**RE: INDIANTOWN COGENERATION PLANT  
DEP FILE NO. 0850102-009-AC  
RAILCAR LIME UNLOADING SYSTEM  
RESPONSE TO APRIL 2, 2007 REQUEST FOR ADDITIONAL INFORMATION**

Attachment IC-EU1-11  
 Lime Handling System  
 Process Flow Diagram  
 Indiantown Cogeneration, L.P.  
 Indiantown, Florida

Re: Indiantown Cogeneration Plant  
DEP File No. 0850102-009-AC  
Railcar Lime Unloading System  
Request for Additional Information

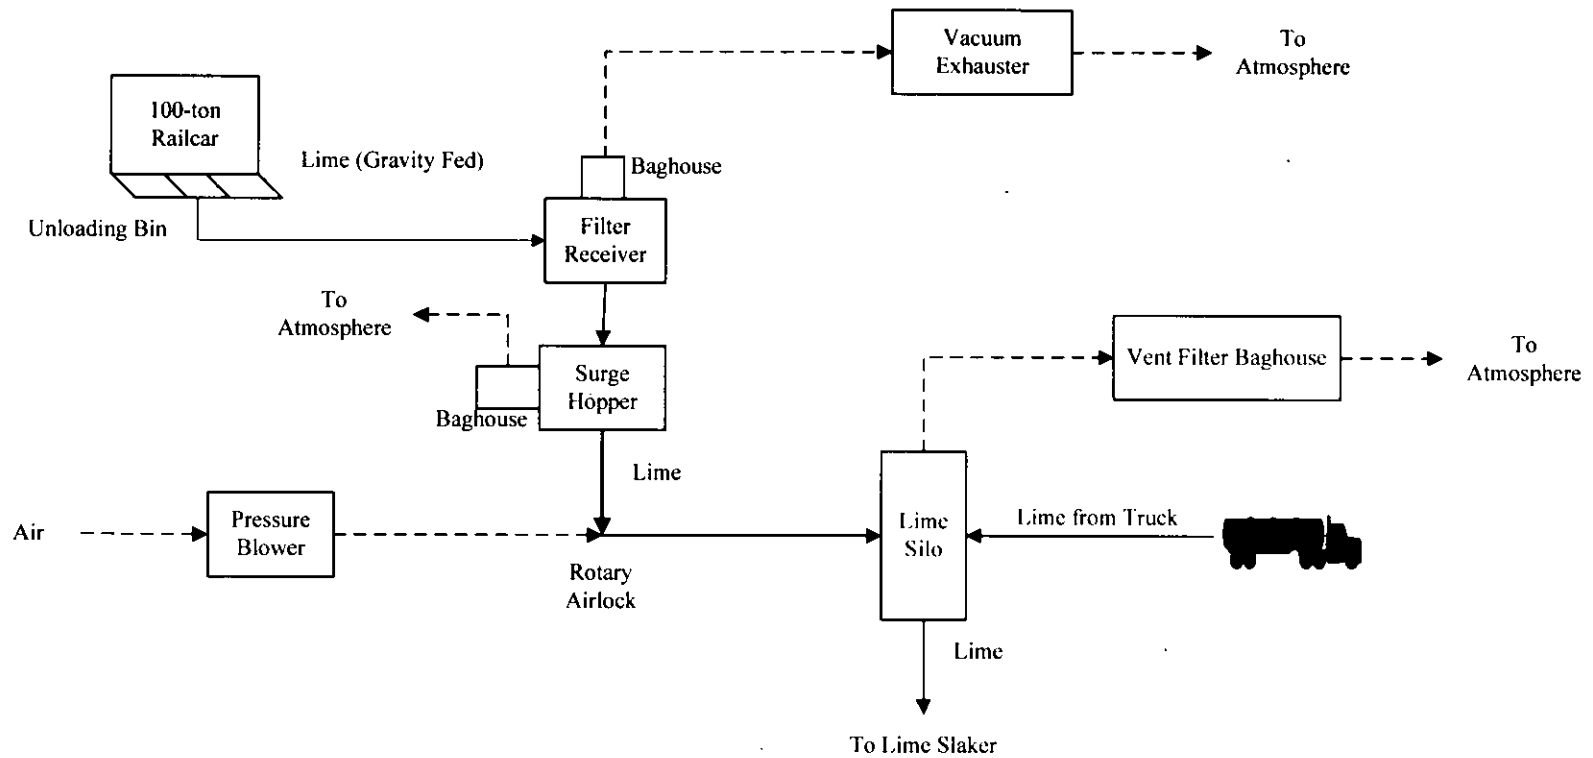
**Comment 4 Please provide detailed schematic drawings of the new railcar unloading system, including interfaces with existing lime handling and pollution control equipment.**

**Response:** A schematic flow diagram of the proposed system was shown in Attachment IC--EU1-II of the application. This diagram shows the existing facilities as well as the proposed facilities. Only the lime silo is included in the existing facility.

Previously, lime was delivered to the facility by pressurized discharge from trucks and vented through the lime silo vent filter. The railcar lime unloading system will use a vacuum exhauster to provide negative pressure into the filter receiver, which acts as both a collection bin and a mechanism to clean the transport of dust particles, since it has an integral baghouse. The new lime transport system will then interface with the existing transport piping to the lime silo. The lime will be conveyed to the lime silo from the filter receiver by a blower through a rotary air lock. The exhaust from the lime silo will continue to be vented through the existing lime silo vent filter.

The existing 4-inch transport piping up the side of the lime silo will remain, and a new 6-inch line will be added. This new line will terminate at a 90-degree elbow that will direct the new lime stream through a new penetration in the roof of the lime silo. This new penetration will be near the penetration for the existing supply line. The existing supply line will be kept in place in order to account for possible railcar supply interruptions, which would make it necessary to receive lime deliveries by trucks.

In the original air construction permit application submitted to the FDEP, exhaust from the airlock surge hopper was vented back to the filter receiver. It has been determined that this design could potentially cause a too-high pressure differential across the rotary airlock. In order to alleviate this concern, another exhaust point has been added to the surge hopper allowing airlock leakage air to escape while keeping the surge hopper at roughly atmospheric pressure and ensuring that the pressure differential across the airlock is 15 pounds per square inch gauge (psig) or less. A baghouse with a cartridge filter will control the PM emissions. Revised application pages and schematic drawings have been provided as attachments to this response.
